ADDENDUM No. 9
 TO THE
 CITY OF FRESNO
 PUBLIC WORKS STANDARD DRAWINGS AND SPECIFICATIONS
 ADOPTED MARCH 4, 1970, BY RESOLUTION NO. 70-36

THIS UPDATED VERSION IS APPROVED: MAY 31, 2024

Addendum 9 to the Public Works Standard Drawings and Specifications, dated May 31, 2024

**STREETLIGHT-WITH BASE
INCLUDES PULL BOX & PVC CONDUIT**

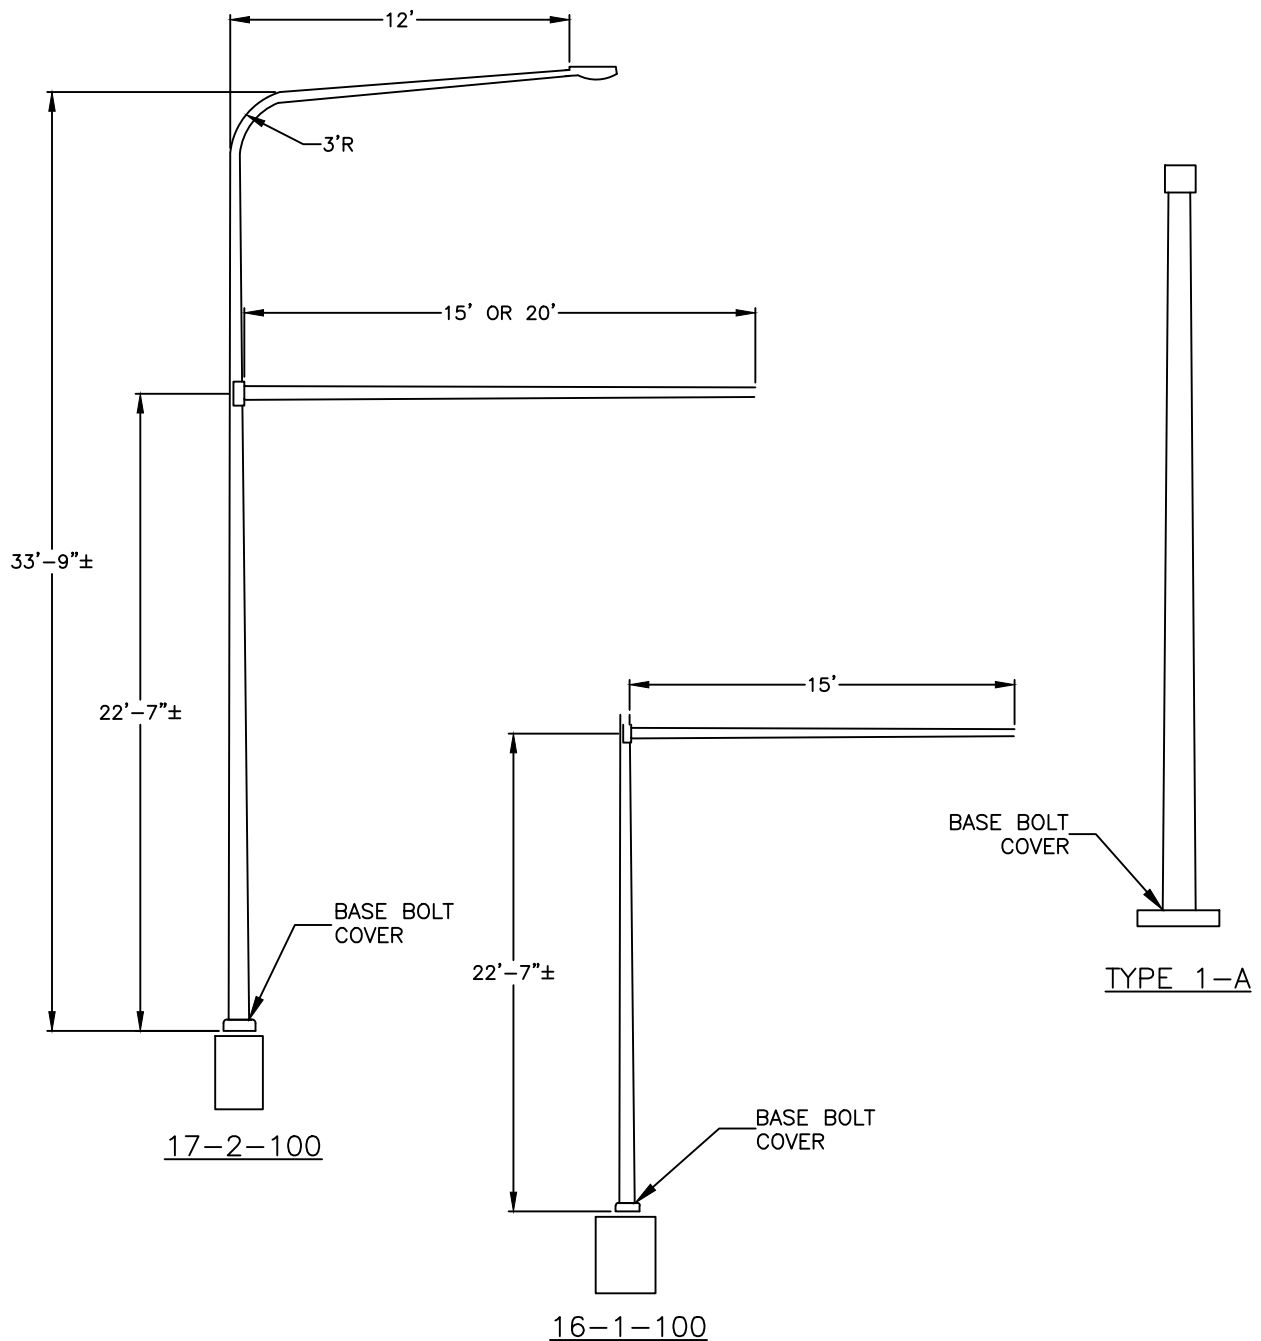
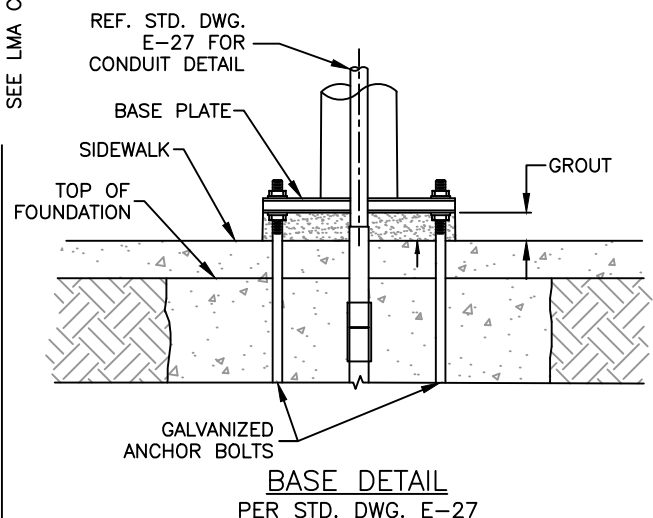
DPW – ELECTRICAL (E Series)	
E-1	<ol style="list-style-type: none"> 1. Note 1, "ALL WORK SHALL CONFORM TO THE APPLICABLE SECTIONS OF THE SPECIFICATIONS ENTITLED "STANDARD SPECIFICATIONS, STATE OF CALIFORNIA, BUSINESS AND TRANSPORTATION AGENCY, DEPARTMENT OF TRANSPORTATION" (1997 REVISION) AND THE NATIONAL ELECTRICAL CODE." revised to read: "ALL WORK SHALL CONFORM TO THE APPLICABLE SECTIONS OF THE CALTRANS STANDARD SPECIFICATIONS (LATEST ADOPTED REVISION) AND THE NATIONAL ELECTRICAL CODE."
E-31	<ol style="list-style-type: none"> 1. Note 3, "POLES MUST MEET CALTRANS 1997 STANDARD SPECIFICATIONS FOR TYPES 1-A, 16-1-113 AND 17B-1-113." Revised to read, "POLES MUST MEET CALTRANS STANDARD SPECIFICATIONS (LATEST ADOPTED REVISION) FOR TYPES 1-A, 16-1-100 AND 17-2-100." 2. Drawing exhibit labels revised to reflect the pole type changes noted above.
E-32	<ol style="list-style-type: none"> 1. Drawing exhibit for pole type 19-3-113 revised as follows: <ol style="list-style-type: none"> a. Exhibit label, "19-3-113" revised to read: "19-3-100". b. Mast arm mounting height dimension, "22'-7"±" revised to read, "22'-8" TO 23'-0"". 2. Drawing exhibit for pole type 24-3-113 revised as follows: <ol style="list-style-type: none"> a. Exhibit label, "24-3-113" revised to read, "24-3-100". b. Mast arm mounting height dimension, "22'-7"±" revised to read, "23'-0"" 3. Note 3, "POLES MUST MEET CALTRANS 1997 STANDARD SPECIFICATIONS FOR TYPES 19-3-113 AND 24-3-113." revised to read, "POLES MUST MEET CALTRANS STANDARD SPECIFICATIONS (LATEST ADOPTED REVISION) FOR TYPES 19-3-100 AND 24-3-100."

DOWNTOWN SIGNAL POLES
DECORATIVE POLE DETAILS - TYPE 26, 29

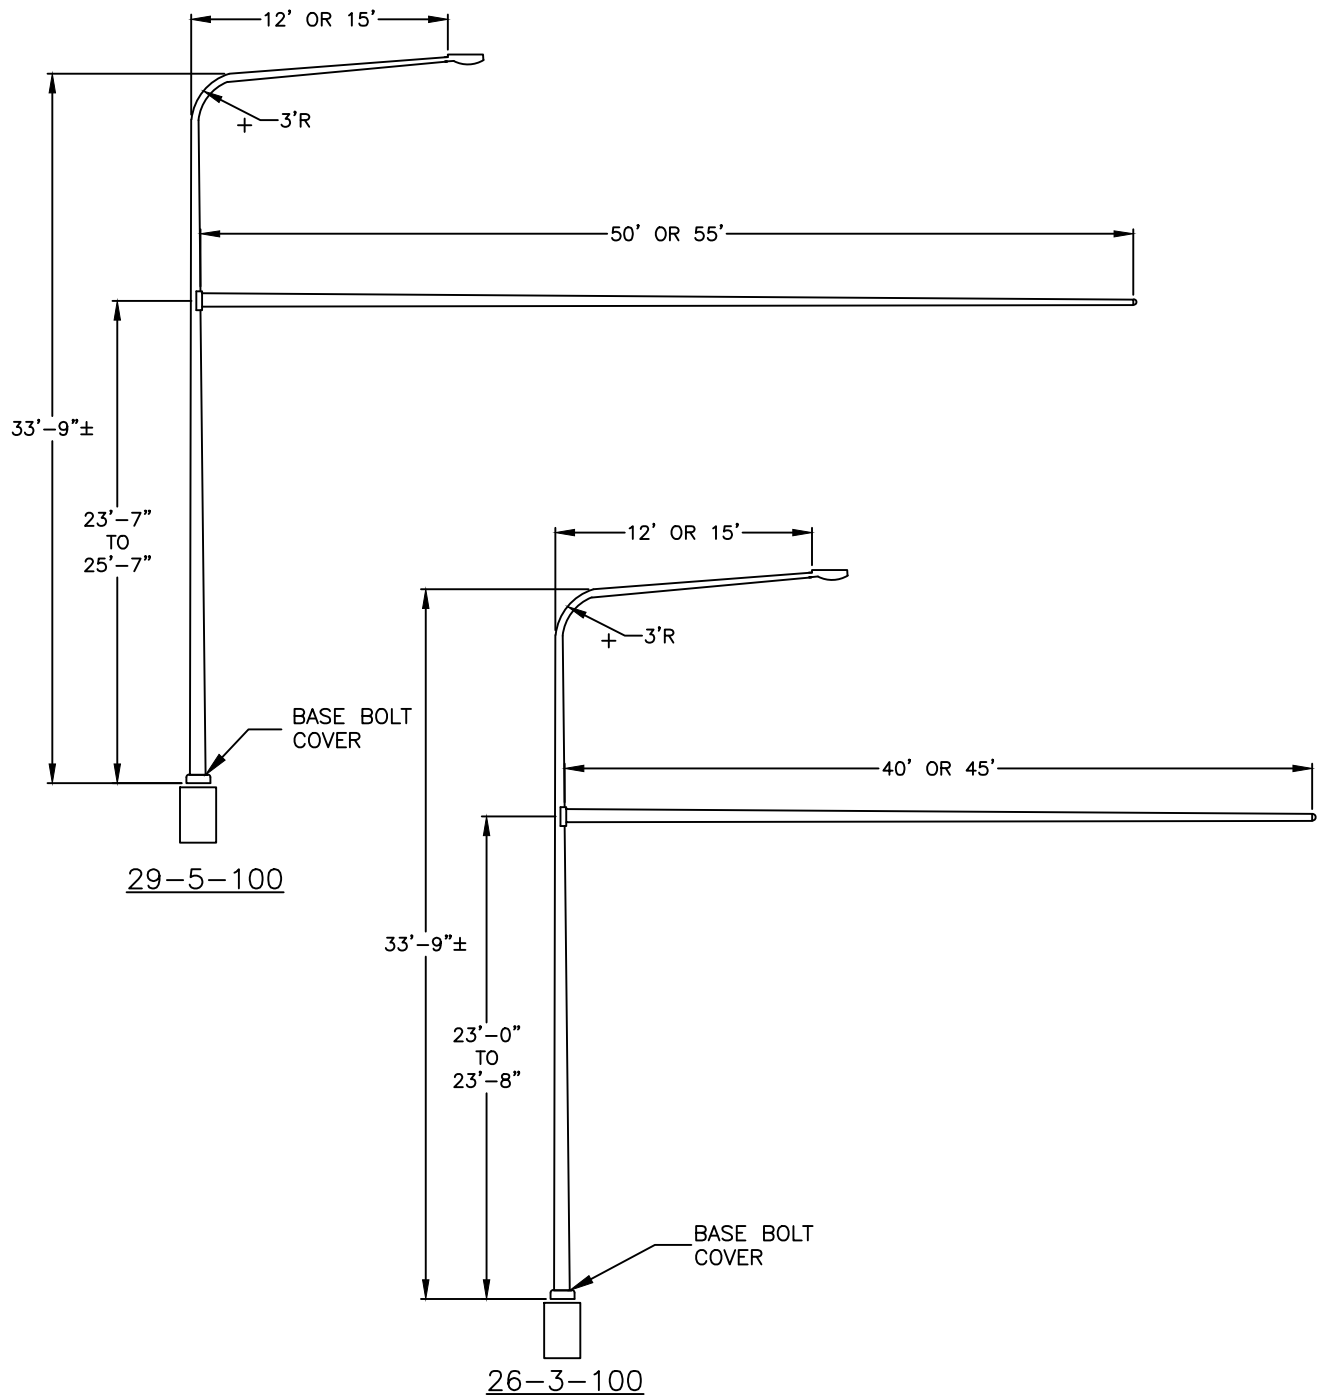
E-33	<ol style="list-style-type: none"> 1. Drawing exhibit for pole type 29-5-113 revised as follows: <ol style="list-style-type: none"> a. Exhibit label, "29-5-113" revised to read "29-5-100". b. Mast arm mounting height, "22'-7"±" revised to read, "23'-7" TO 25'-7"" 2. Drawing exhibit for pole type 26-3-113 revised as follows: <ol style="list-style-type: none"> a. Exhibit label, "26-3-113" revised to read, "26-3-100". b. Mast arm mounting height dimension, "22'-7"±" revised to read, "23'-0" TO 23'-8"" 3. Note 3, "POLES MUST MEET CALTRANS 1997 STANDARD SPECIFICATIONS FOR TYPES 29-5-113 AND 26-3-113." revised to read, "POLES MUST MEET CALTRANS STANDARD SPECIFICATIONS (LATEST ADOPTED REVISION) FOR TYPES 29-5-100 AND 26-3-100."

1. THE DECORATIVE POLE STANDARDS SHALL APPLY TO THE "DOWNTOWN FRESNO AREA" AS DEFINED BY P.W. STD. DWG. E-29.
2. POLE FINISH: BASE COAT - HOT DIP GALVANIZE TO ASTM A123
FINISH COAT - TGIC OR URETHANE POLYESTER POWDER
COLOR - BRONZE TO MATCH ADJACENT DECORATIVE POLES
3. POLES MUST MEET CALTRANS STANDARD SPECIFICATIONS (LATEST ADOPTED REVISION) FOR TYPES 29-5-100 AND 26-3-100.
4. MATCHING BASE BOLT COVERS SHALL BE INSTALLED.
